Product Change Notification

1. ECN #: 299762

- IDSD - INSULATION DISPLACEMENT TERMINAL CABLE

New modified body pic 1

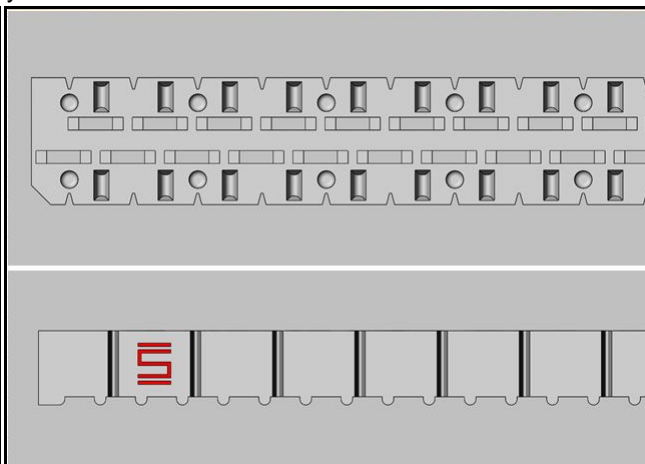
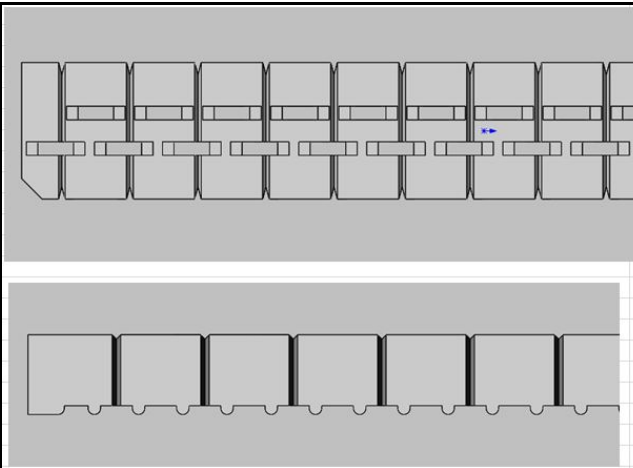
Add void corings on the top surface and change material from PBT VALOX DR-48 to PBT 4521.

Visual inspection; voids will be noticed on the top of body where prior revision had no voids; this is a rolling change and there is some opportunity for mixed inventory on a limited basis.
